PLAN COMMISSION REPORT

Proposal: Amended Site Plan & Architectural Plans – Multi-tenant Industrial Building

Description: Review amended site and architectural plans for a proposed multi-tenant speculative industrial building.

RE: Site and Building Plan updates 10000 S. Ridgeview Drive (Tax Key 9269038000)

C2.0

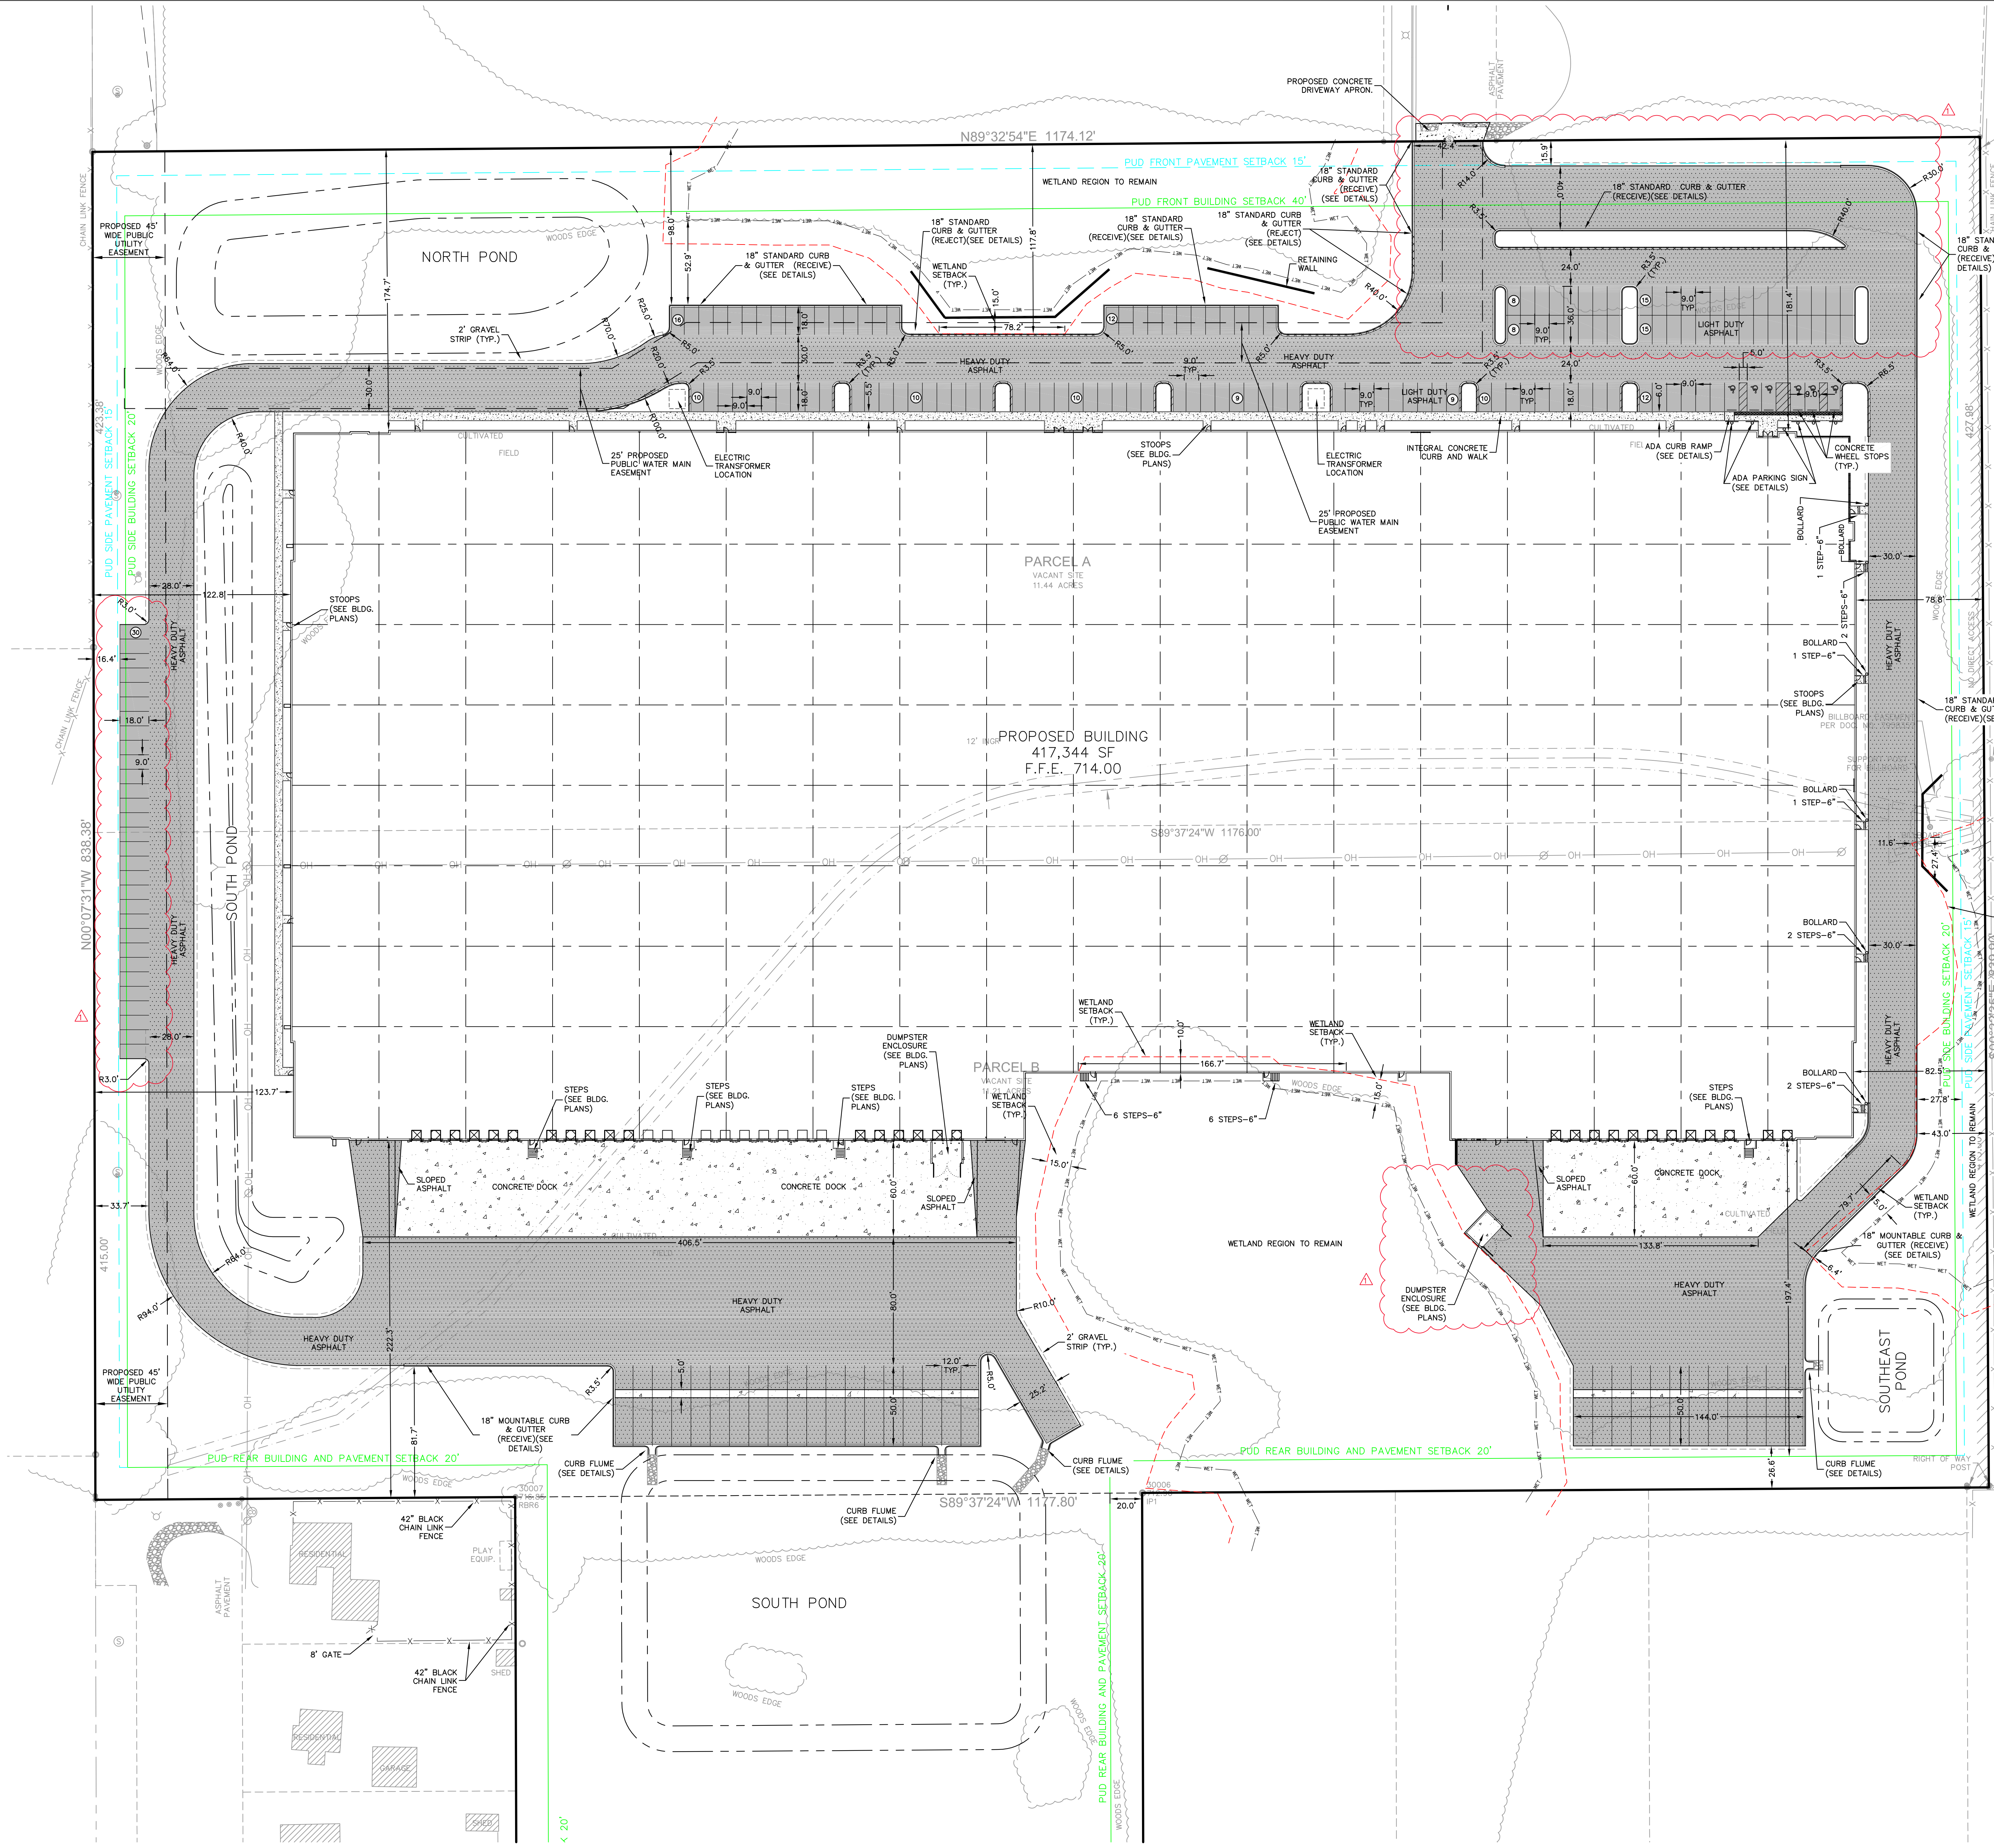
- b) Slight increases to truck drive width to make maneuvers easier for ingress and egress.
- c) Adjust parking stall areas to accommodate the truck drive width increase, the addition of the necessary electric transformers for the building, and other minor modifications. More specifically:

- i. A total of 28 vehicle parking stalls were removed from the northeast area.
 - ii. The east-west landscape buffer separating the truck drive from the vehicle parking in the northeast area was significantly enhanced.

- iii. A total of 30 vehicle parking stalls were added to the west side of the site, 32 plantings were added to the north of those parking stalls at the west property line transition area adjacent to an M-1 property, and 30 plantings were added to the south of those parking stalls at the west property line transition area adjacent to an M-1 property.

- d) Move the trash enclosure from the east end of the southeast loading dock area to the west end of the southeast loading dock area for full dock usage.

A201

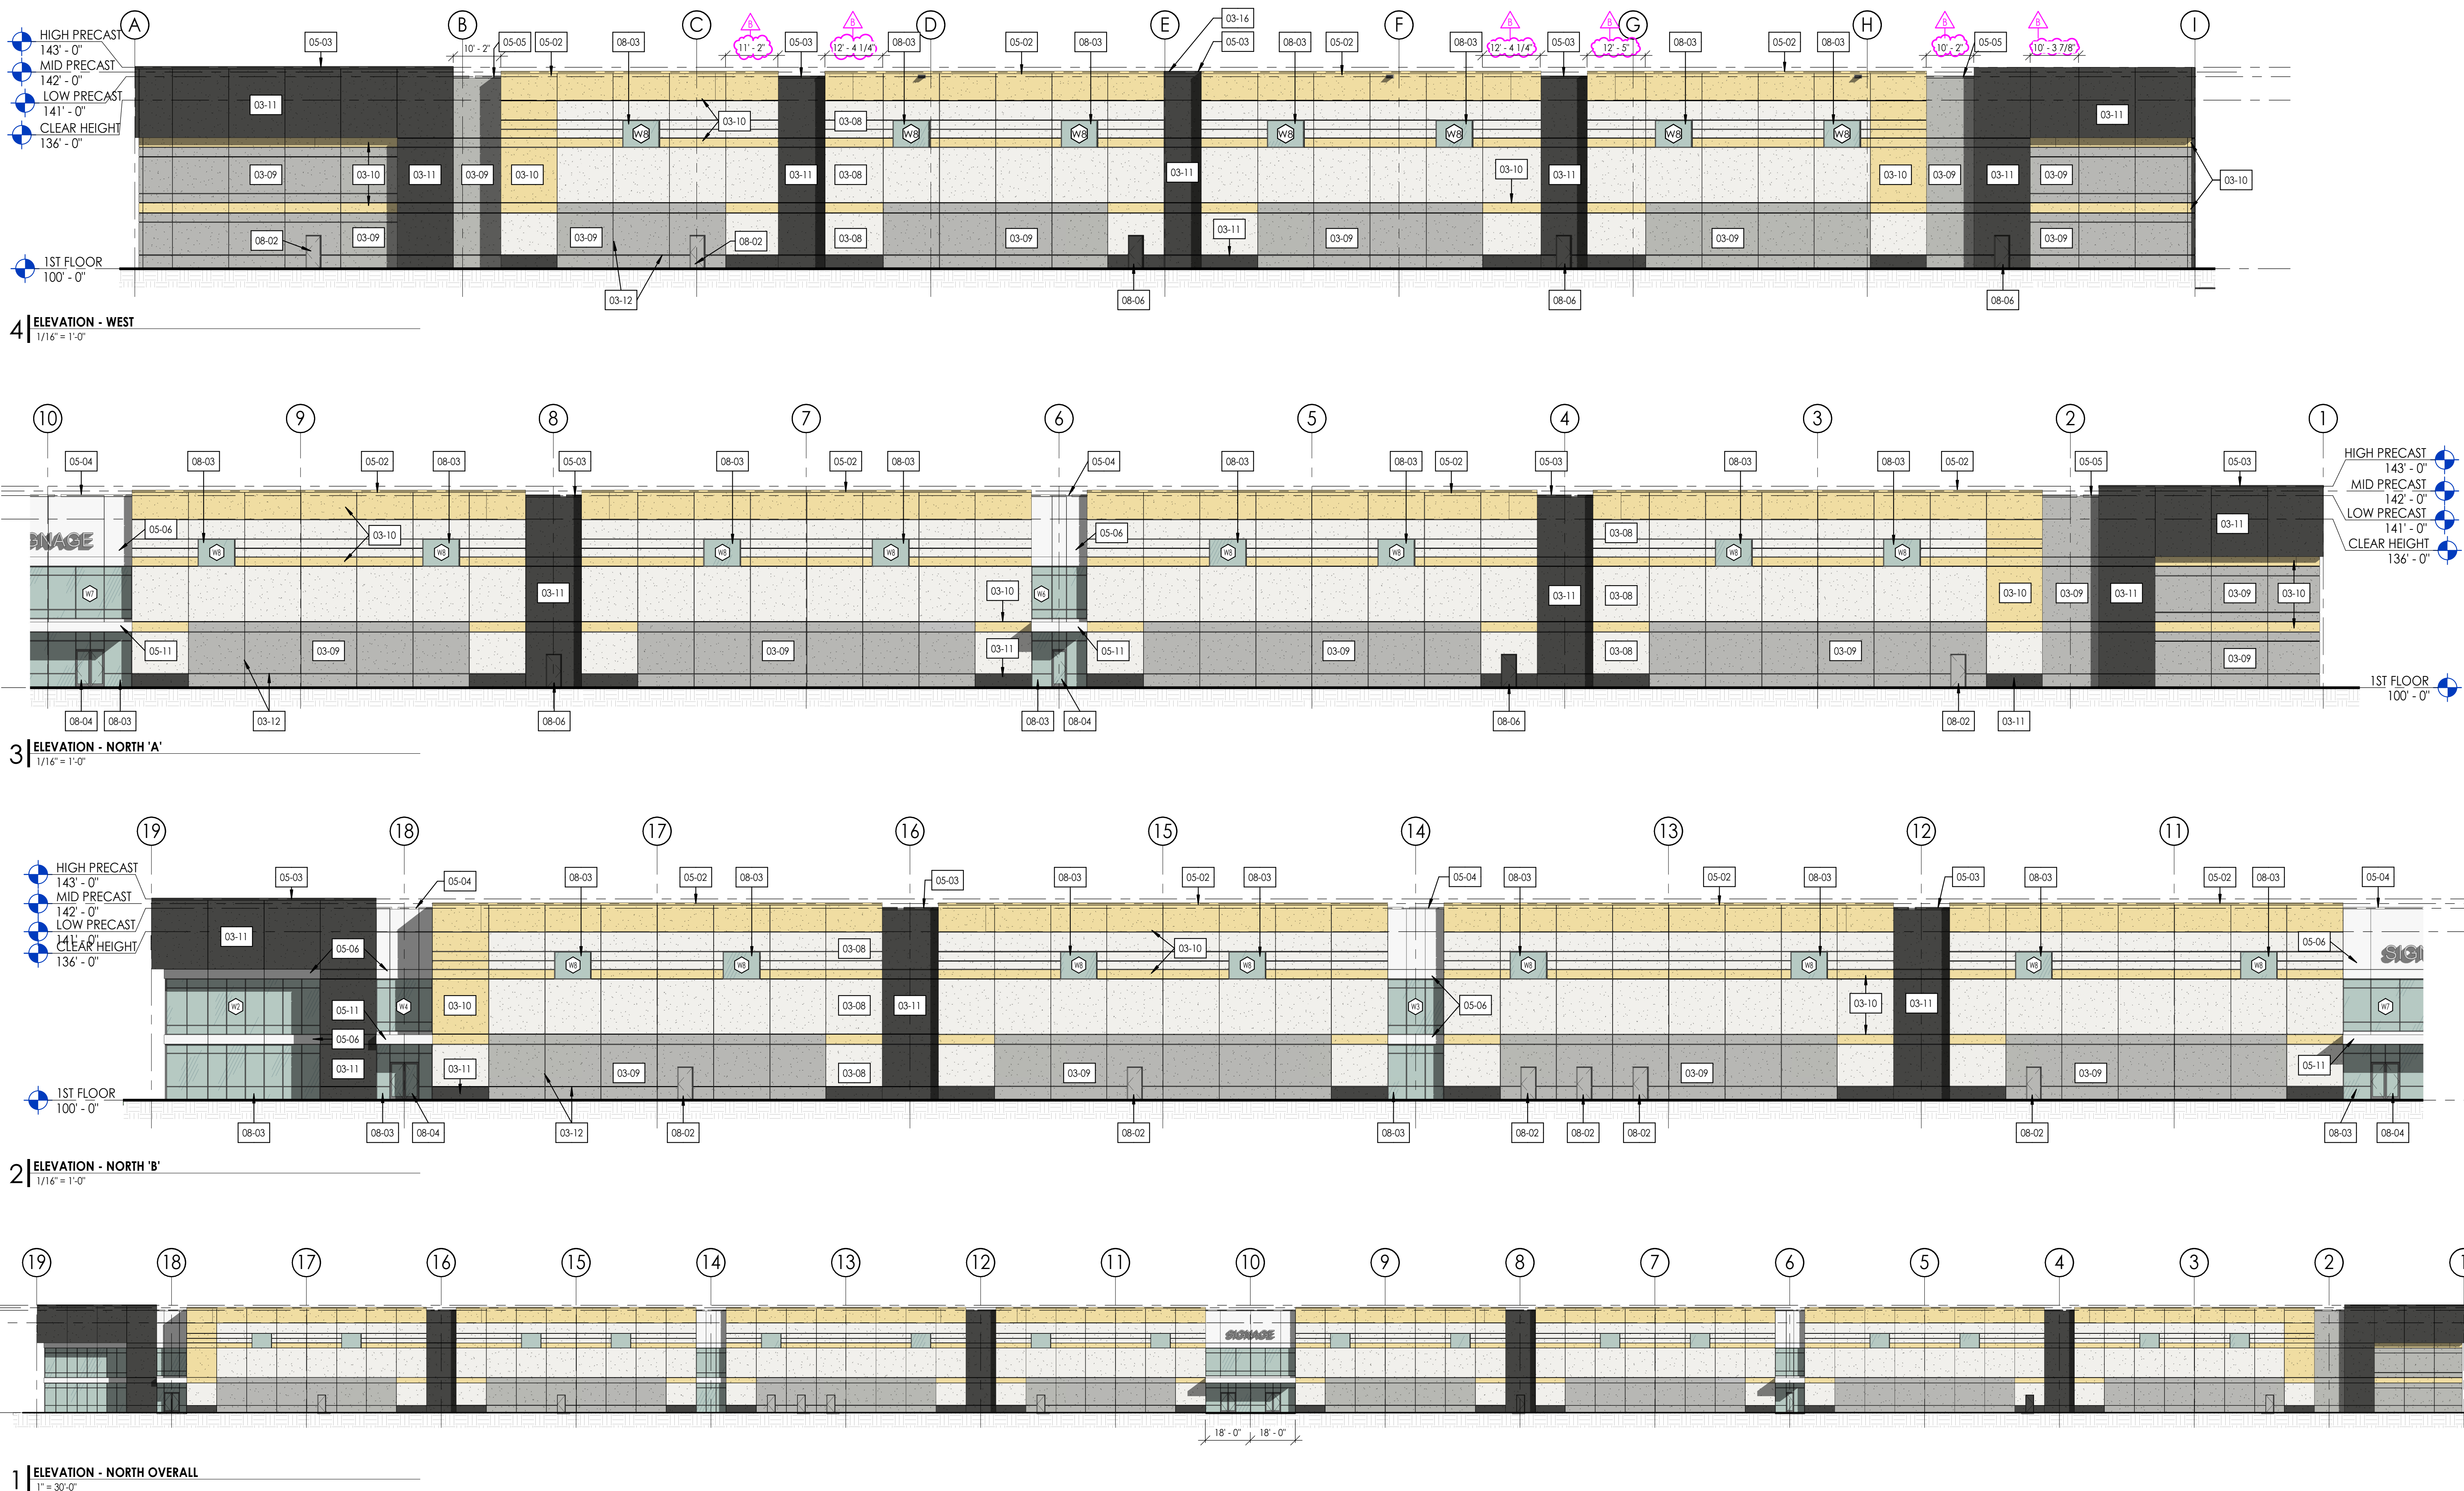
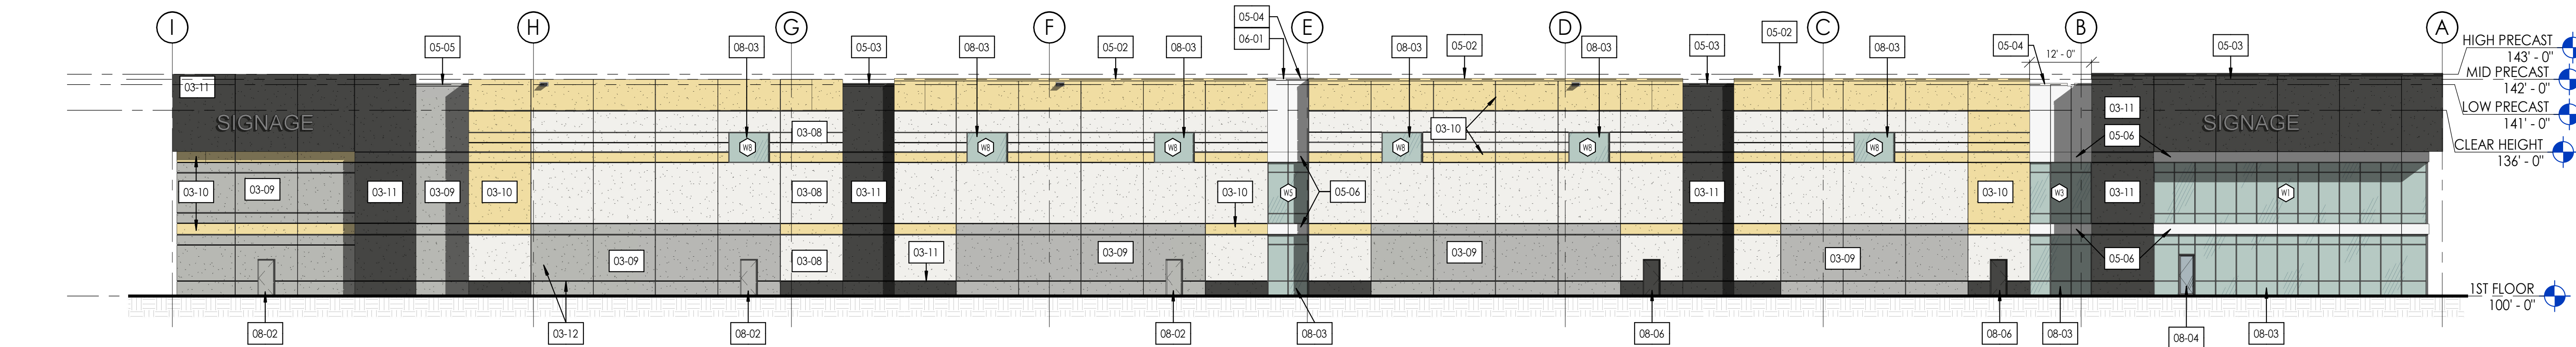
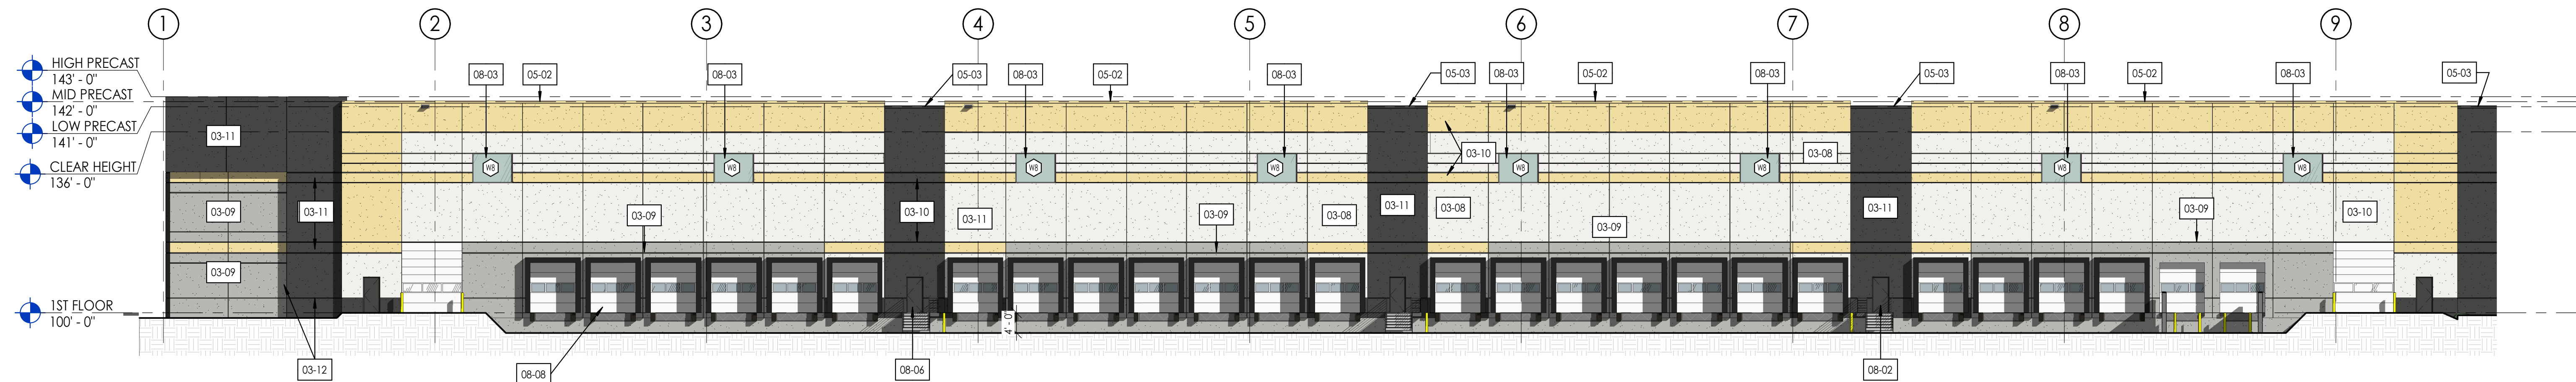
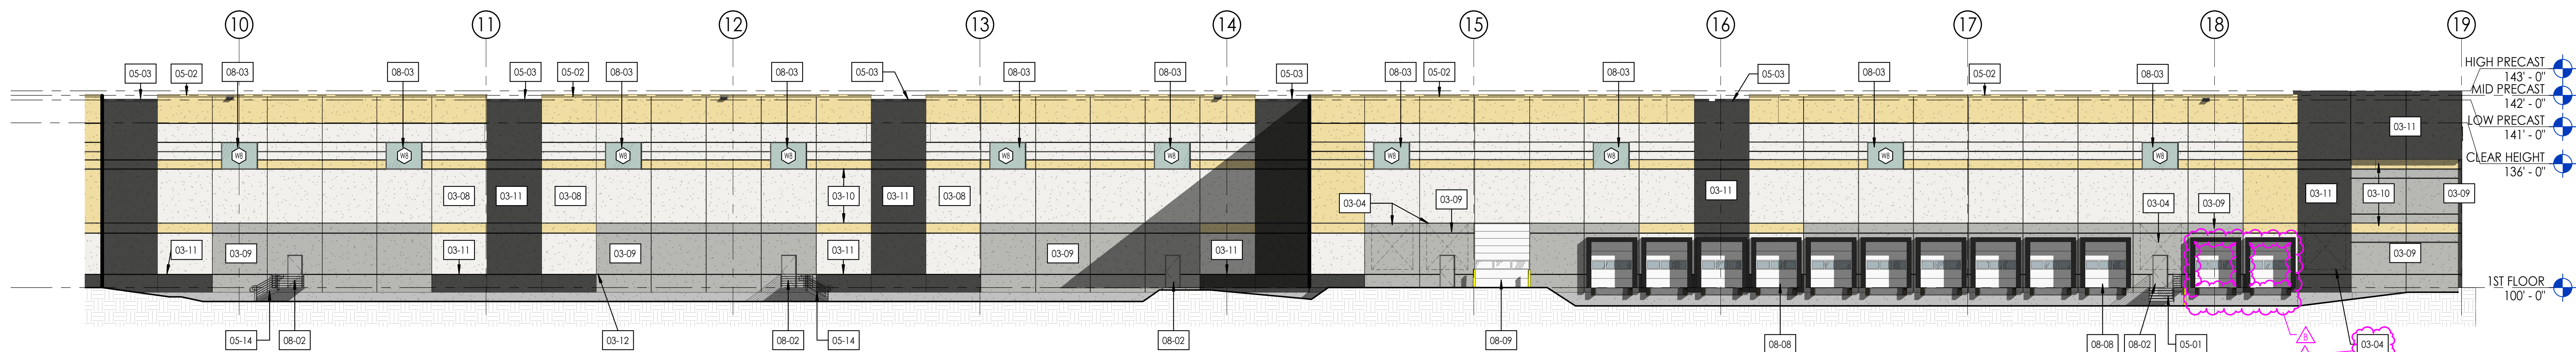
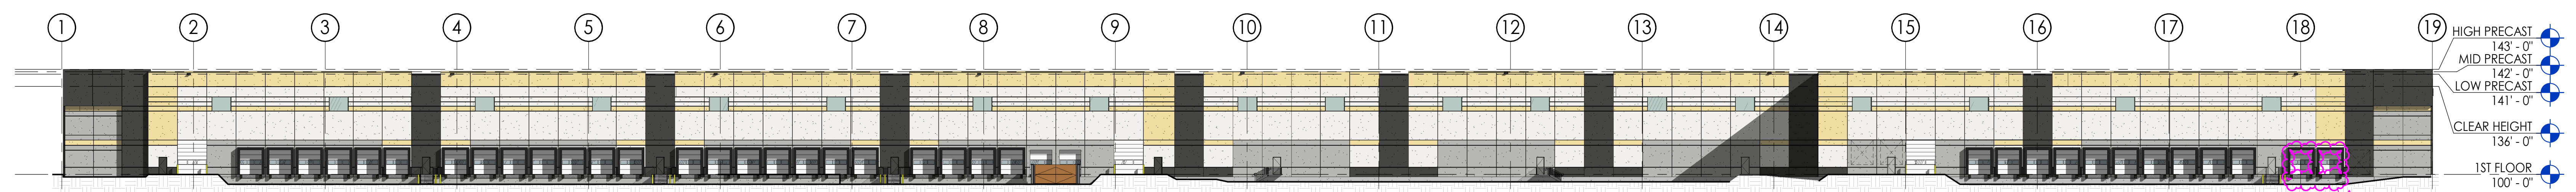
- i. Per trash enclosure relocation, add bumpers to dock doors D1 and D2. This will also ensure that D1 and D2 dock doors match all other dock doors.
- e) Minor building elevation changes.

- i. As a result of receiving more accurate and detailed drawing dimensions and to ensure doors remain aligned to the centerline of precast panels, minor dimensional updates made to exact door locations on the west elevation.

- ii. Elevation updated to show precast knockout panel east of dock door D1.
